SERVICE **No.** 516 LETTER

Piper Aircraft Corporation

March 7, 1969

Fuel Cell Vent System Modification

RECESSED ANTI-ICING FUEL CELL VENT

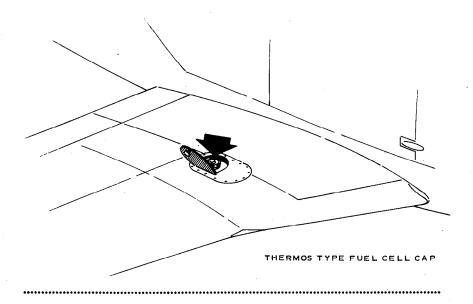
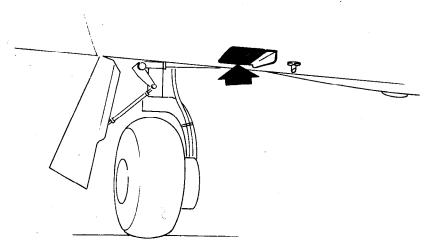
To provide the necessary material and instructions to accomplish installation of an improved fuel cell venting system incorporating recessed NACA type anti-icing fuel cell vents which will minimize the possibility of fuel cell vent restriction resulting in fuel cell collapse. (See lower portion of sketch on reverse side of this letter.)

Also included are 1/2 inch forward facing fuel drain tubes to minimize difficulties that could occur as a result of loose fuel tank caps; and sealing material is provided to preclude the entrance of water into the fuel quantity gauge sender recess.
